Well Name: RED HILLS UNIT	Well Location: T25S / R33E / SEC 33 / NENW / 32.092844 / -103.579122	County or Parish/State: LEA / NM
Well Number: 47H	Type of Well: OIL WELL	Allottee or Tribe Name:
Lease Number: NMNM0024368A, NMNM024368A	Unit or CA Name:	Unit or CA Number:
US Well Number: 3002548454	Well Status: Approved Application for Permit to Drill	Operator: CIMAREX ENERGY COMPANY OF COLORADO

Sundry ID: 2739375

Type of Submission: Notice of Intent	Type of Action: APD Change
Date Sundry Submitted: 07/05/2023	Time Sundry Submitted: 01:21
Date proposed operation will begin: 01/01/2024

Cimarex Energy Company of Colorado respectfully requests the following drilling and directional changes be made to the existing, approved APD for the following well:

Coterra Red Hills Unit 47H Rev1 kFc 24May23
of 3
24-May-2023

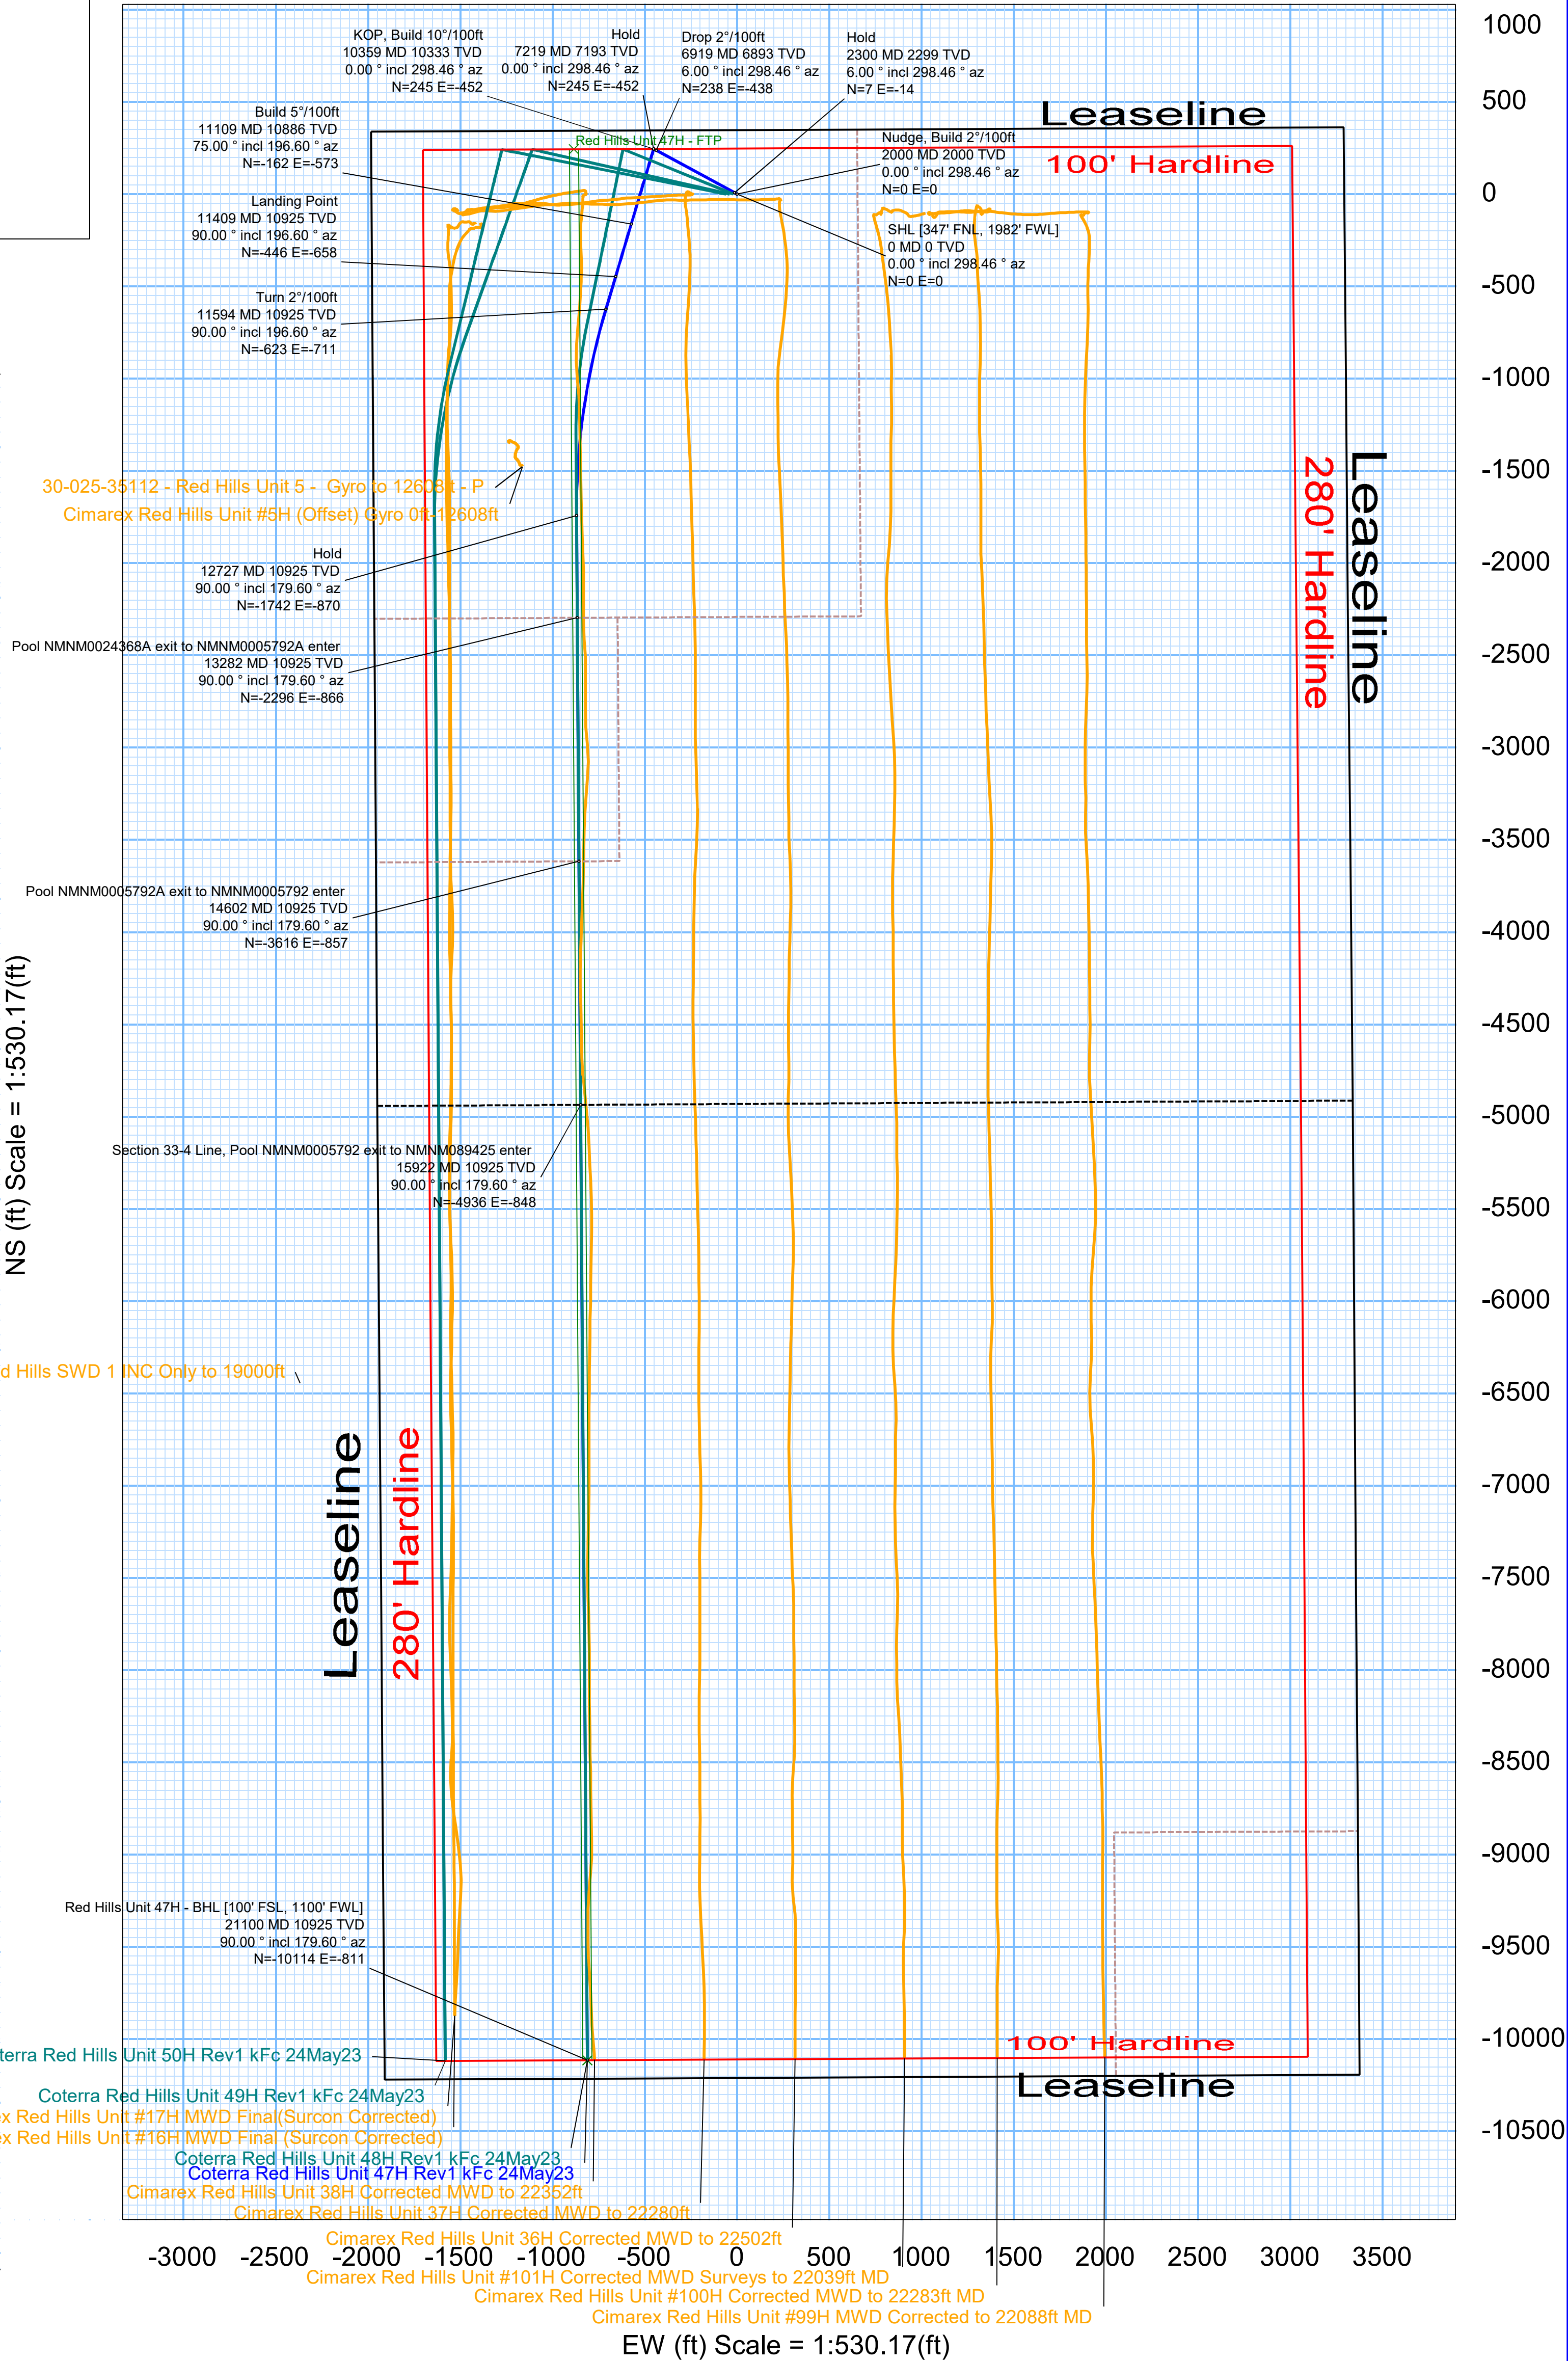
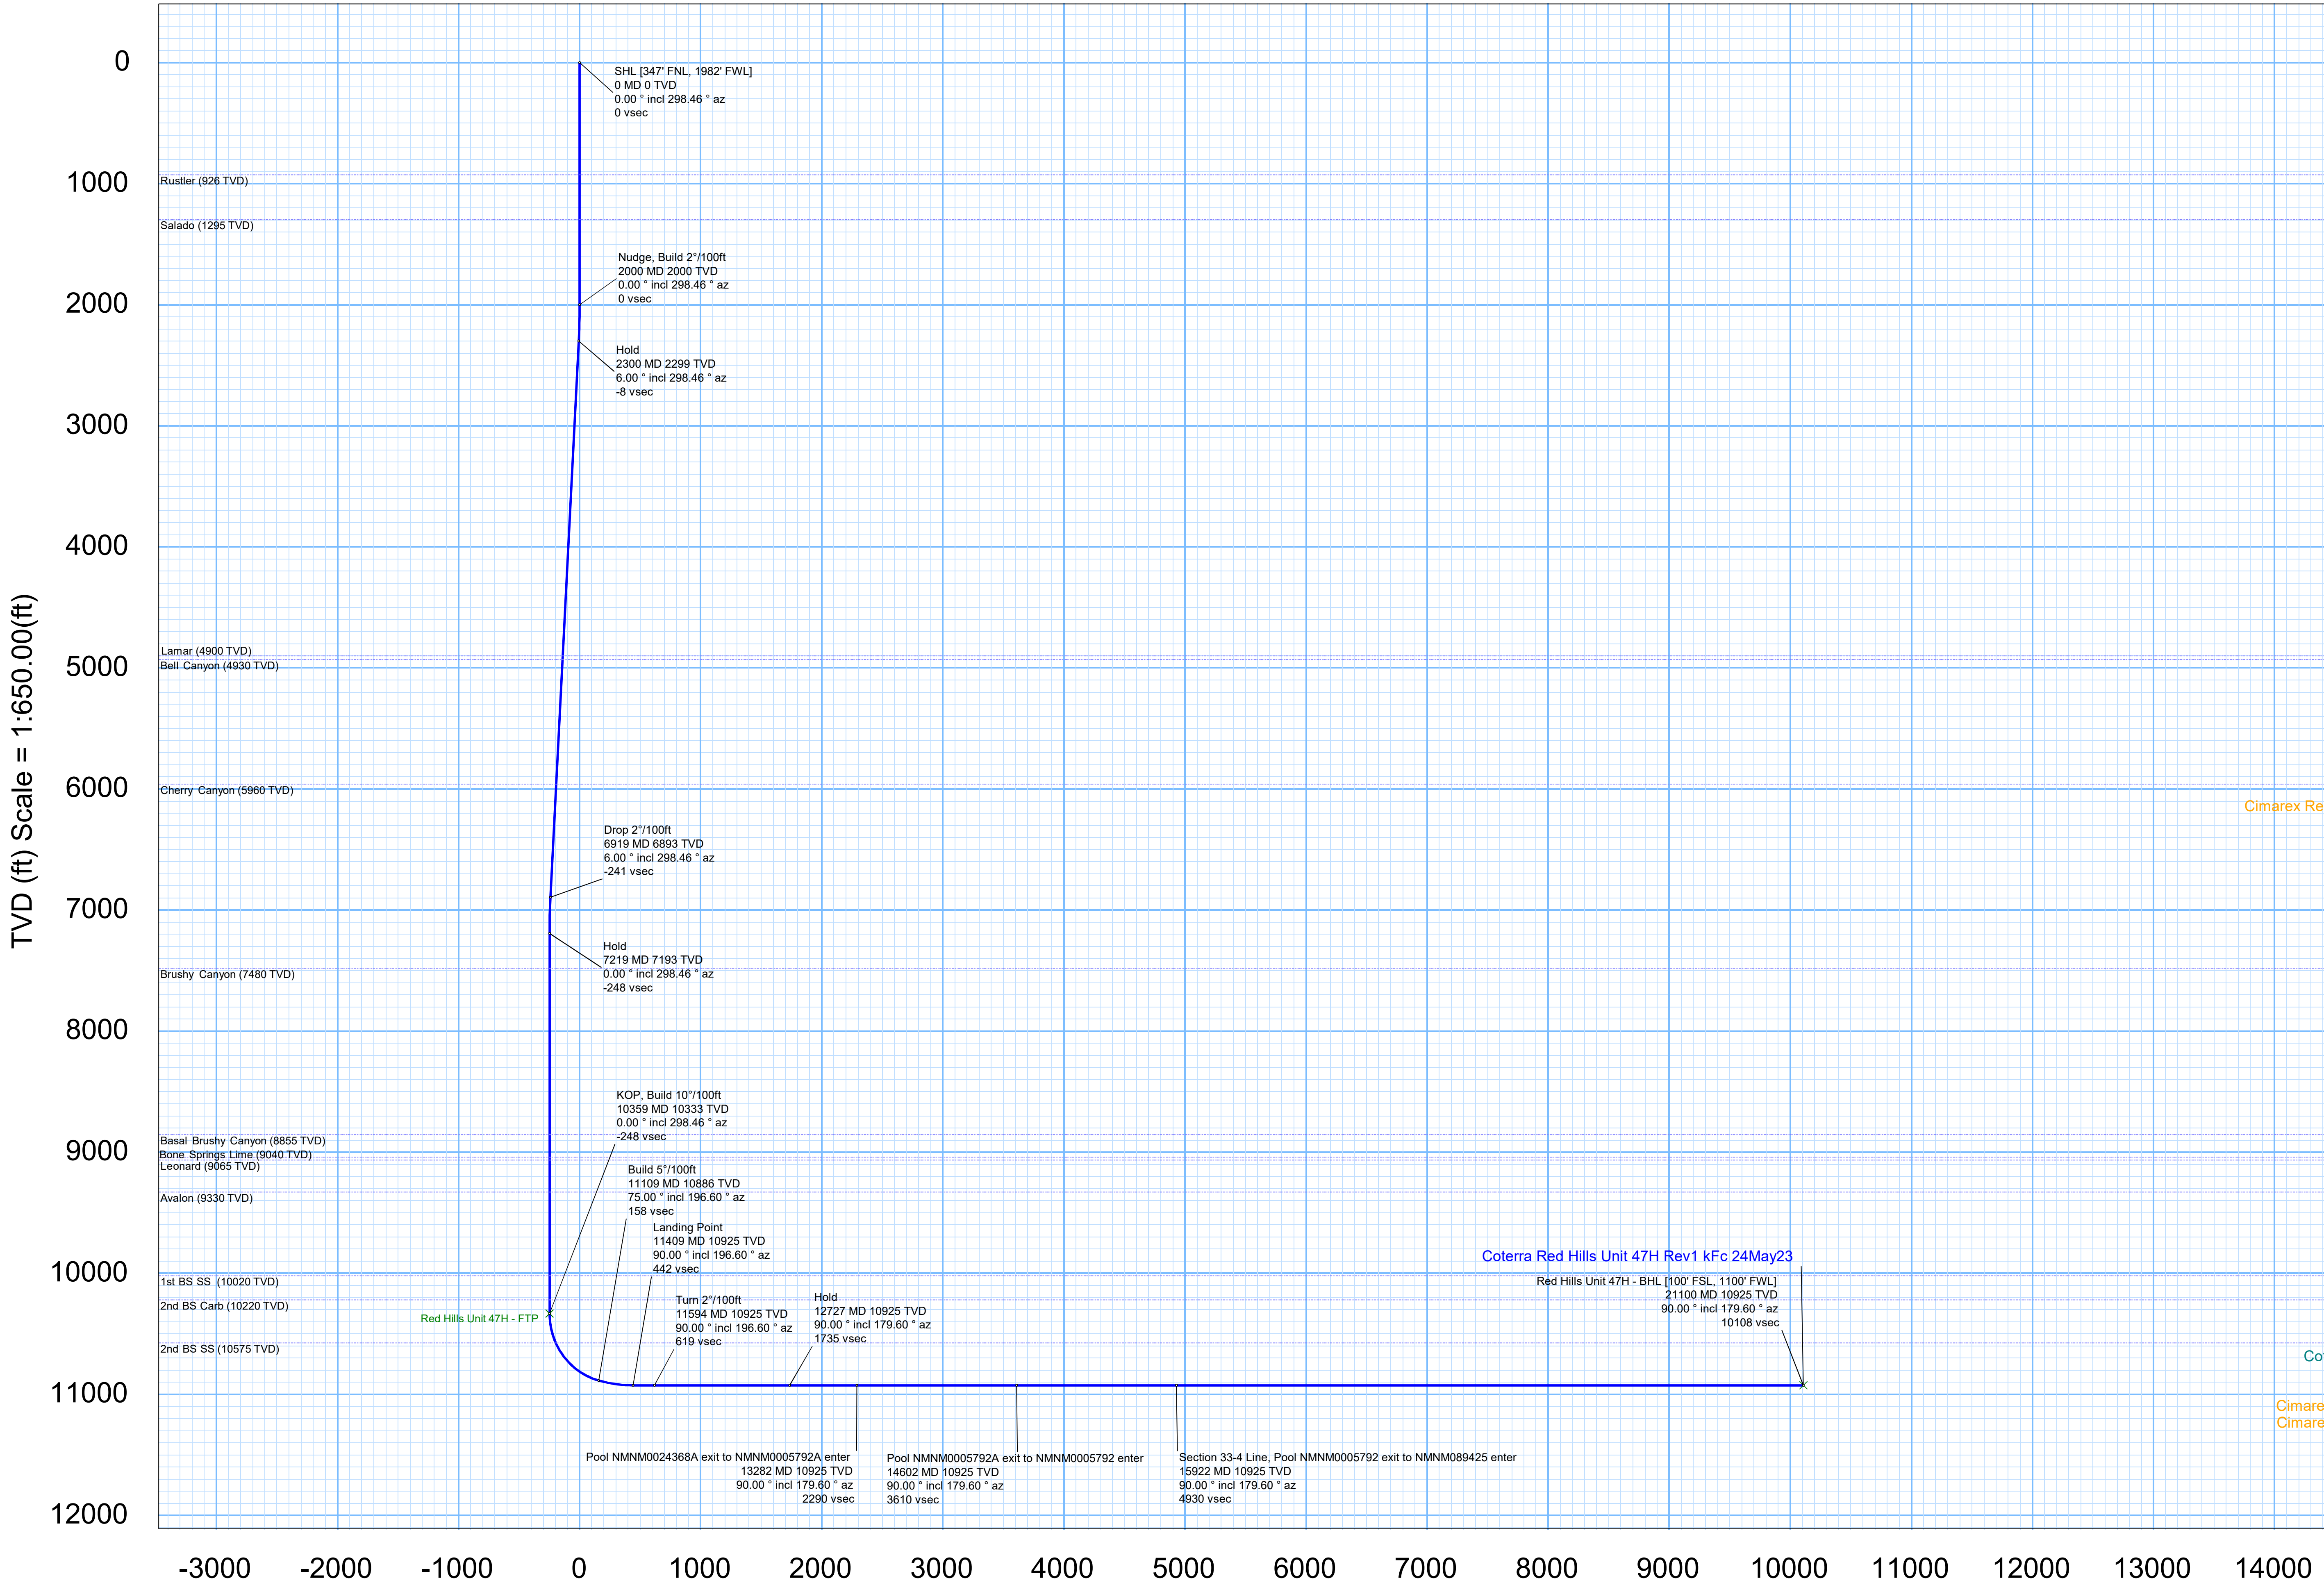
The AFMSS Location Table does not match the points in the C-102 & Directional Plan attached to the approved APD

Exit point #1 was called out at 0' FNL of Section 4, which would not account for the bottom lateral portion of the producing wellbore.

Wellbore	NS-Foot	NS Indicator	EW-Foot	EW Indicator	Twsp	Range	Sec	Aliquot/Lot/Track	Latitude	Longitude	County	State	Meridian	Lease Type	Lease Number	Elevation	TVD	MD
SHL #1 Leg	347	FNL	1982	FWL	25S	33E	33	NENW	32.09334	-103.579379	LEA	NEWMEXICO	NEWMEXICO	F	NMNM0024368A	3361	0	0
KOP #1 Leg	102	FNL	1530	FWL	25S	33E	33	NENW	32.09402241	-103.58083244	LEA	NEWMEXICO	NEWMEXICO	F	NMNM0024368A	-6998	10333	10359
PPP #1-1 Leg	100	FNL	1100	FWL	25S	33E	33	NWNW	32.094025	-103.582227	LEA	NEWMEXICO	NEWMEXICO	F	NMNM0024368A	-8048	10925	11409
PPP #1-2 Leg	2640	FNL	1101	FWL	25S	33E	33	NWSW	32.087045	-103.582226	LEA	NEWMEXICO	NEWMEXICO	F	NMNM0005792A	-8048	10925	13950
PPP #1-3 Leg	1320	FSL	1102	FWL	25S	33E	33	SWSW	32.083417	-103.582226	LEA	NEWMEXICO	NEWMEXICO	F	NMNM0005792	-8048	10925	15270
PPP #1-4 Leg	0	FNL	1102	FWL	25S	33E	4	NWNW	32.079789	-103.582226	LEA	NEWMEXICO	NEWMEXICO	F	NMNM089425	-8048	10925	16590
EXIT #1 Leg	100	FSL	1100	FWL	25S	33E	4	SWSW	32.065557	-103.582225	LEA	NEWMEXICO	NEWMEXICO	F	NMNM089425	-8048	10925	21100

BHL #1 Leg	100	FSL	1100	FWL	25S	33E	4	SWSW	32.065557	-103.582225	LEA	NEWMEXICO	NEWMEXICO	F	NMNM089425	-8048	10925	21100
